SB Number:	SB 2BG-016	Creation Date: 03/08/2006
Subject:	Measure against strange sounds heard from the fuser section	
Model:	FS-C8026N, KM-C2630/C2630D

FUSER DRIVE SECTION

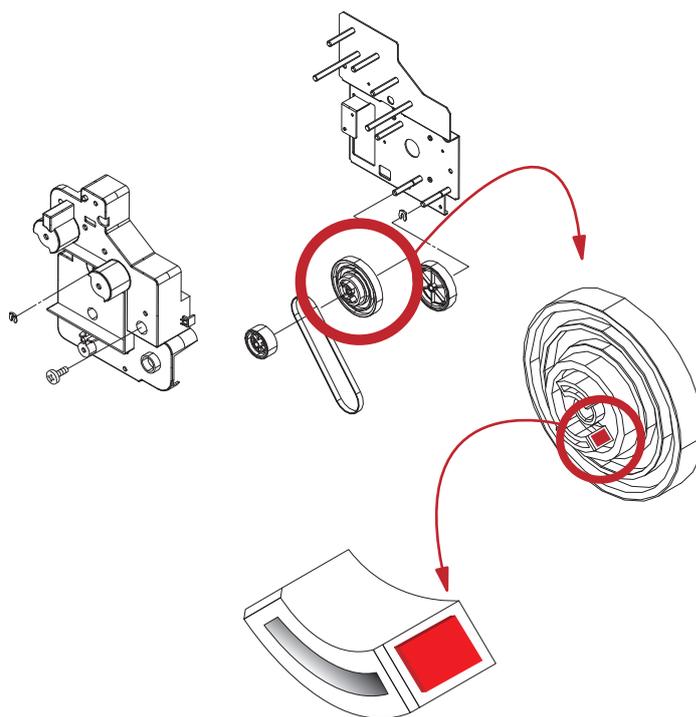
Because the joints section of the gears (2BG2249_/2BG2246_) in the fuser drive assy can have a small gap, there is a possibility that an abnormal sound (The clicking sound) is heard at every rotation.

To reduce the chance that the gears joint section produces unwanted noise, the SPACER GEAR will be supplied as a spare parts to fill up the space causing the gear knocking.

When an abnormal sound is heard coming from the FUSER DRIVE ASSY, please attach the SPACER GEAR.

SPACER GEAR, p/n: 302BG68360
